NORTHERN BEACHES COUNCIL SUPPLEMENTARY ASSESSMENT REPORT

Panel Reference	PPSSNH-499
DA Number	DA2024/0499
LGA	Northern Beaches Council
Proposed Development	Demolition works and construction of three residential flat buildings
Street Address	Lot 1 DP 213608, 120 Frenchs Forest Road West FRENCHS, Lot 2 DP 213608, 118 Frenchs Forest Road West FRENCHS FOREST, Lot 14 DP 25713, 11 Gladys Avenue FRENCHS FOREST and Lot 24 DP 25713, 116 Frenchs Forest Road West FRENCHS
Applicant/Owner	BMHP Group Pty Ltd
Date of DA lodgment	13/05/2024
Number of Submissions	7 (original public exhibition, noting amended scheme is not required to be re-exhibited)
Recommendation	The Panel consider the contents of this supplementary assessment report and associated change to the recommendation in the original assessment report from refusal to approval, subject to conditions.
Regional Development Criteria (Schedule 7 of the SEPP (State and Regional Development) 2011	General development exceeding \$30 million CIV

Report prepared by	Steve Findlay – Manager Development Assessment
Report date	30 May 2025

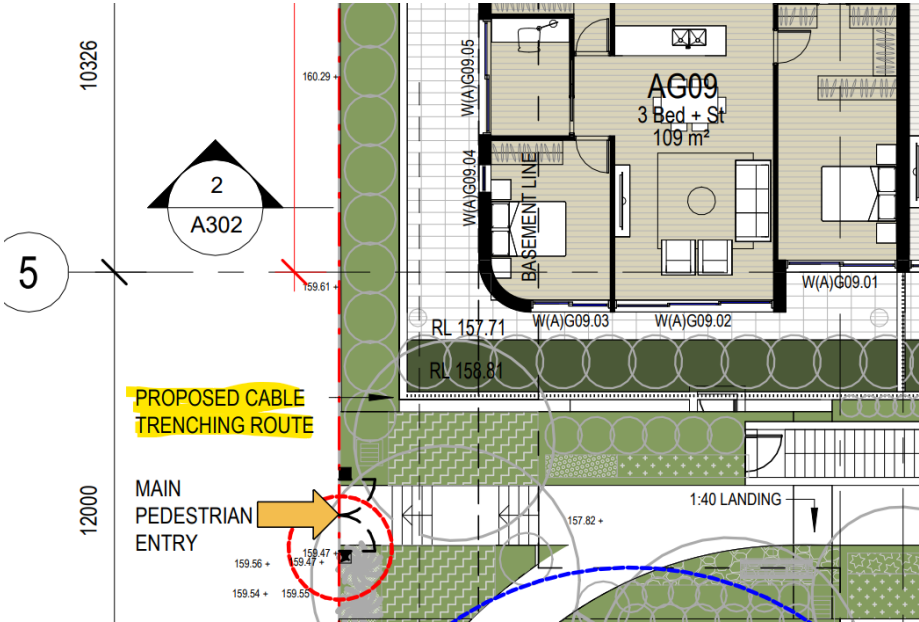
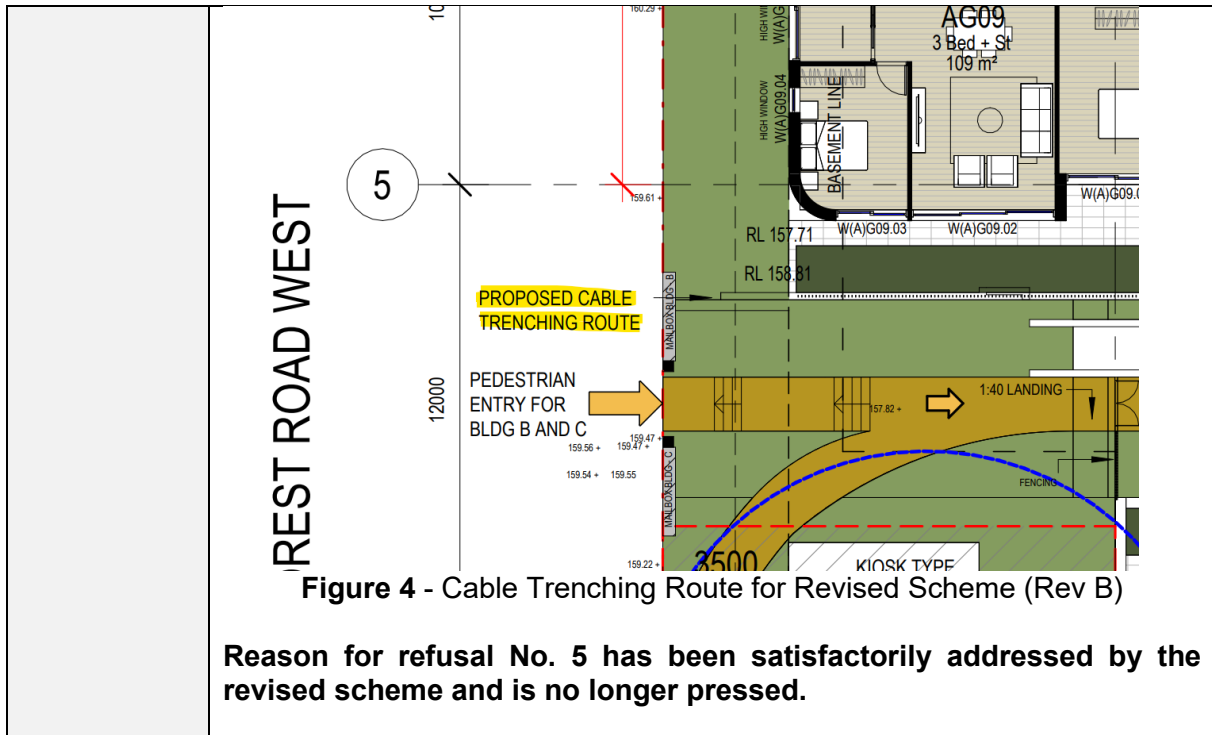
Applicant	<p>The Applicant makes the following comments on how the amended application addresses Reason 3.</p> <p><i>“The proposal utilises the full 30% FSR and building height bonuses applicable to infill affordable housing pursuant to Chapter 2 of SEPP Housing. The plans have been amended to ensure strict compliance with the building height standard and accordingly the application does not rely on a clause 4.6 variation request.</i></p> <p><i>This draft reason for refusal has been appropriately addressed.”</i></p>					
Council Assessment Officer	<p>The revised scheme (Revision B) has reduced the height of the two non-compliant elements of the original scheme (Revision A, involving lift overrun on Building A and the lift overrun on Building C), and now fully complies with the SEPP height bonus provisions as follows:</p>					
		Standard	Requirement	Proposed	% Variation	Complies
		Height of Buildings	<u>Buildings A and B</u> 22.75m (17.5m + 30%)	<u>Buildings A & B</u> 22.75m	Nil	Yes

16.9m (13m + 30%)	16.9m		
<p>The height reduction from Rev A plans to Rev B plans is shown below:</p>  <p>Figure 1 – Height Blanket for Previous Scheme (Rev A)</p>  <p>Figure 2 – Height Blanket for Revised Scheme (Rev B)</p> <p>Therefore, as the proposal has been reduced in height to comply with the SEPP building height controls, the proposal satisfies the provisions of the SEPP and no longer relies upon a Clause 4.6 variation.</p> <p>Reason for refusal No. 3 has been satisfactorily addressed by the revised scheme and is no longer pressed.</p>

Figure 7 - Landscape Setbacks for Building B (Previous Scheme - Rev A)

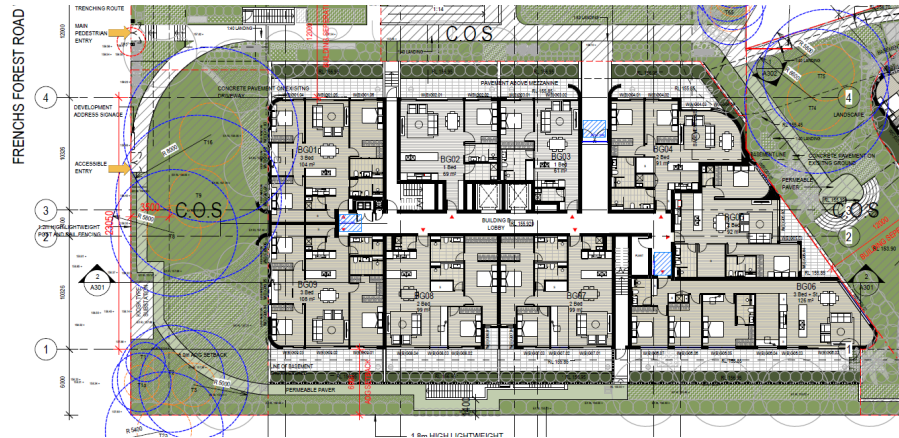
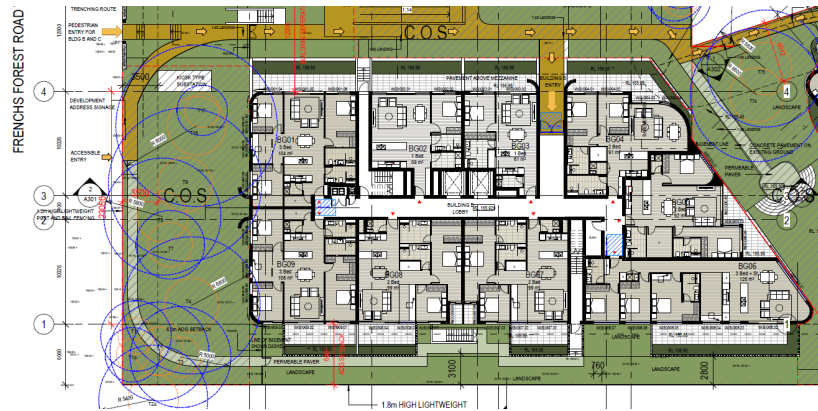
Applicant	<p>The Applicant makes the following comments on how the amended application addresses Reason 9.</p> <p><i>"As previously indicated, the architectural and landscape plans have been amended to provide additional deep soil compensatory planting opportunity to ensure that the DCP provisions are satisfied.</i></p> <p><i>This draft reason for refusal has been appropriately addressed."</i></p>
Council Landscape Officer	<p>Council's Landscape Officer has reviewed the amended plans and reports and provided the following comments:</p> <p><i>The concerns raised in the referral comments dated 11/12/24 have generally been addressed, and as such landscape referral is supportive of the proposal subject to the imposed conditions. The planting proposal generally represents an "urban forest" and is "making a feature of the forest" which is sought under the desired future character of the DCP.</i></p>

Figure 8 - Landscape Setbacks for Building B (Revised Scheme - Rev B)

Reason for refusal No. 9 has been satisfactorily addressed by the revised scheme and is no longer pressed.

Figure 9 – Bin Holding Area Previous Scheme (Rev A)

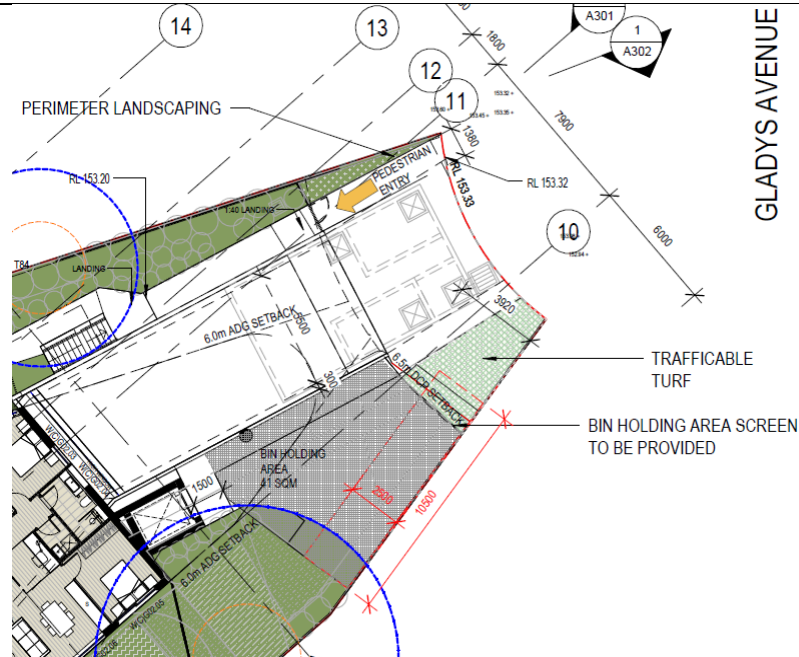
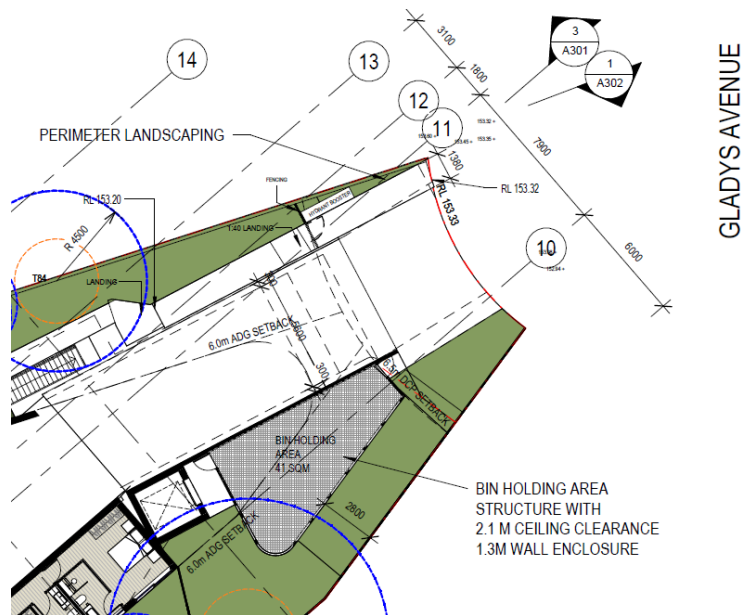
Applicant	<p>The Applicant makes the following comments on how the amended application addresses Reason 10.</p> <p><i>“These matters have been comprehensively addressed as previously outlined within this supplementary statement.</i></p> <p><i>This draft reason for refusal has been appropriately addressed”.</i></p>
Council Assessment Officer	<p>The revised plans have removed excessive hard paved areas and structures within the front and side setbacks which allows for greater deep soil landscaping and canopy tree planting.</p> <p>The amended proposal provides for the following changes to the landscaping:</p> <p>Building A – The 3.5m front setback now comprises deep soil, with new canopy tree planting and minimal pedestrian pathways and the hydrant booster has been removed from the front boundary.</p> <p>Building B – The 6.0m front setback now comprises deep soil, with retention of significant canopy trees and relocated kiosk substation.</p> <p>Building C – The 6.5m front setback now comprises landscaped area on the eastern side of the driveway (“Trafficable Turf” deleted), and a 2.8m landscaped side setback to the bin holding area, as shown below:</p>

Figure 10 – Bin Holding Area Revised Scheme (Rev B)

Reason for refusal No. 10 has been satisfactorily addressed by the revised scheme and is no longer pressed.
--	--------------------------------------------------------------------------------------------------------------------
